Project	<b>IEEE 802.16 Broadband Wireless Access Working Group</b> < <a href="http://ieee802.org/16">http://ieee802.org/16</a> >	
Title	<b>Handover - MSS Release after Completing Initial Network Entry</b>	
Date Submitted	<b>2004-06-07</b>	
Source(s)	Yong-Ho Kim Kihyoung Cho Changjae Lee LG Electronics, Inc. 533,Hogye-1dong,Dongan-gu, Anyang-shi,Kyongki-do,Korea	Voice: 82-31-450-4387 Fax: 82-31-450-7912 <a href="mailto:ronnykim@lge.com">mailto: ronnykim@lge.com</a> <a href="mailto:kihyoung@lge.com">kihyoung@lge.com</a> <a href="mailto:cjlee16@lge.com">cjlee16@lge.com</a>
Re:	Response to IEEE 802.16-04/19 (Recirculation Ballot #14a)	
Abstract	Handover - MSS Release after Completing Initial Network Entry	
Purpose	Enhance the handover performance during handover	
Notice	This document has been prepared to assist IEEE 802.16. It is offered as a basis for discussion and is not binding on the contributing individual(s) or organization(s). The material in this document is subject to change in form and content after further study. The contributor(s) reserve(s) the right to add, amend or withdraw material contained herein.

# Handover - MSS Release after Completing Network

### 3. Proposed Ch

Figure. Proposed Scheme and Resuming Communication in Case of A drop.

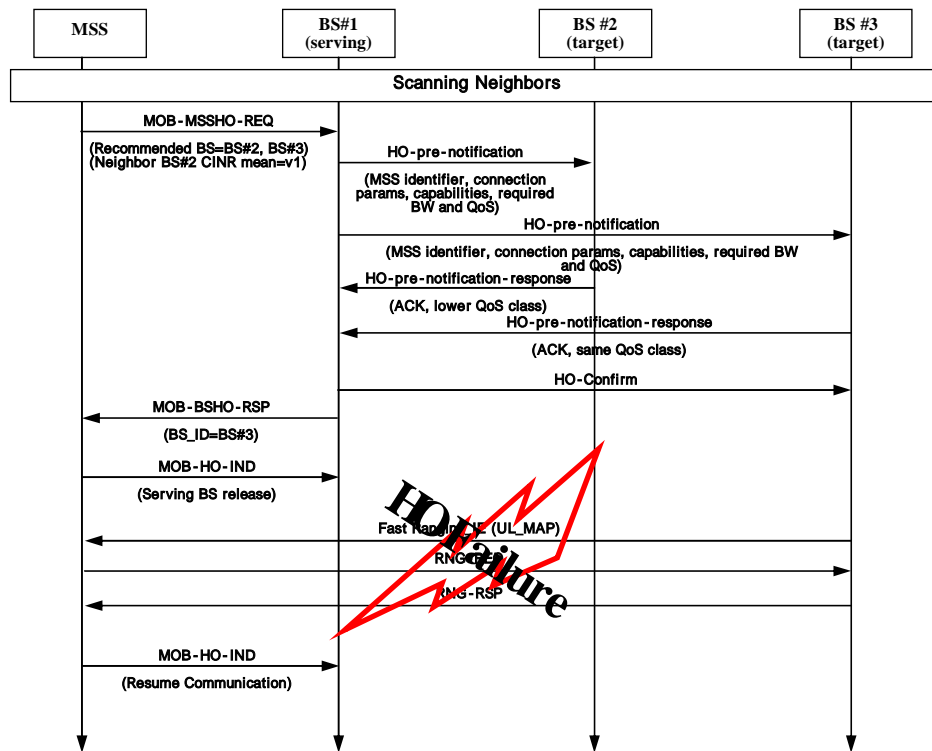
If the successful handover of an MSS can be informed to the serving BS, the serving BS can release the MSS's connection related information at the time of reception of successful handover message. If a drop occurs during HO, the MSS can try to resume communication with the serving BS at first and if this fails then the MSS shall attempt network re-entry with its preferred target BS.

Figure E.8 – Example HO process by MSS request

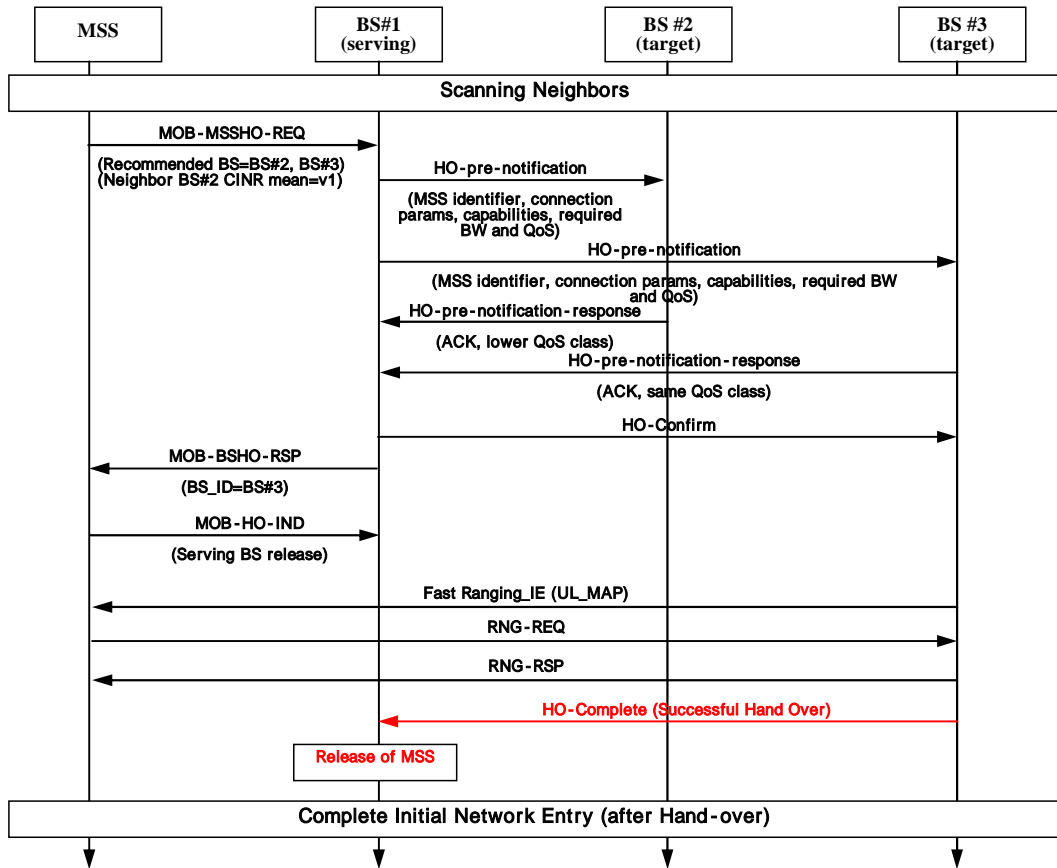
Correct sentences describing BS's and MSS's actions for the serving BS to release MSS information after reception of HO-complete backbone message. Add one HO\_IND\_type in MOB-HO-IND to indicate to the serving BS that decision of data forwarding shall be indicated back to the MSS. Add one backbone message from the target BS to the serving BS to indicate MSS's successful handover.
